Access Compliance Report Public Rights-of-Way (Curb Ramps)

Main Street: BOLSA_AVE Cross Street: VAN_BUREN_ST Location: NW

ADA ID: RPRK210930110927 Ramp Type: Type 1 - Perpendicular Diagonal Initial Pass/Fail: Pass Overall Compliance: No Severity Score: 16

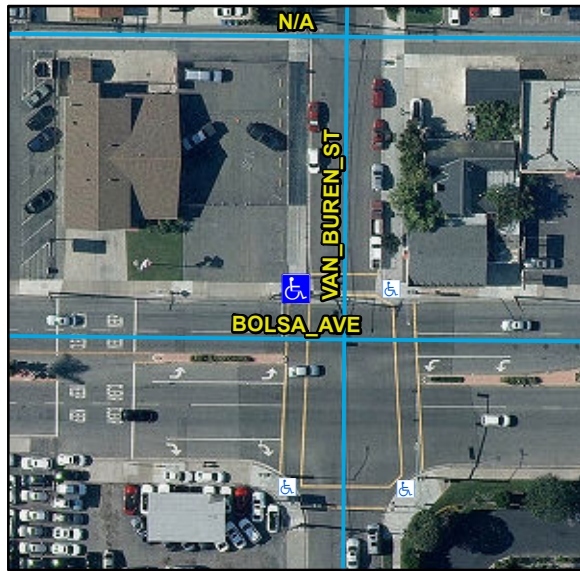
Compliance	Description	Data	Compliance	Description	Data
N/A	Ramp Length (in)	107	N/A	Flare Type LT	
Yes	Ramp Width (in)	48			Sloped
Yes	Ramp Run Slope (%)	1.9	N/A	Flare Slope LT (%)	5.7
No	Ramp Cross Slope (%)	2.2	N/A	Flare Traversable LT	No
N/A	Landing Present	No	N/A	Flare Type RT	
N/A	Landing Length (in)	N/A			Sloped
No	Landing Width (in)	N/A	N/A	Flare Slope RT (%)	7.7
No	Landing Run Slope (%)	N/A	N/A	Flare Traversable RT	No
No	Landing Cross Slope (%)	N/A	Yes	DWS Provided	Yes
N/A	Landing Movement Obstructed?	No	Yes	DWS Contrast	Yes
	Landing Movement Type	N/A	Yes	DWS Length (in)	36
N/A	Landing Shared	N/A	Yes	DWS Full Width	Yes
Yes	Clear Space	Yes	Yes	DWS Offset Left (in)	0
Yes	Clear Space To Crosswalk (in)	48	Yes	DWS Offset Right (in)	N/A
N/A	Marked Crosswalk 1	Yes	N/A	Marked Crosswalk 2	Yes
	Crossing 1 Direction	S		Crossing 2 Direction	E
	Marked Crosswalk 1 Width (in)	140		Marked Crosswalk 2 Width (in)	140

Yes	Ramp Inside Crosswalk 1	Yes	Yes	Ramp Inside Crosswalk 2	No
	Crossing 1 Slope (%)	11.7		Crossing 2 Slope (%)	2
	Crossing 1 Cross Slope (%)	2.3		Crossing 2 Cross Slope (%)	1.1
Yes	Gutter Ponding	No	N/A	Curb Slope	1.9
Yes	Gutter Lip Height (in)	0		Road Run Slope (%)	1.1
No	Gutter Run Slope (%)	6.5		Road Cross Slope (%)	2.8
No	Gutter Cross Slope (%)	2.1			
Yes	Overall Surface Condition: Acceptable		Yes	Perp Joint Present	Yes
	Cross Gutter Present?	Yes		Spandrel Present?	Yes
	Replace Cross Gutter?	No		Replace Spandrel?	No

Remove & Replace Curb Ramp With Two New Directional Ramps or Equivalent. Restripe Crosswalk. Remove & Replace Gutter. Utility Present.
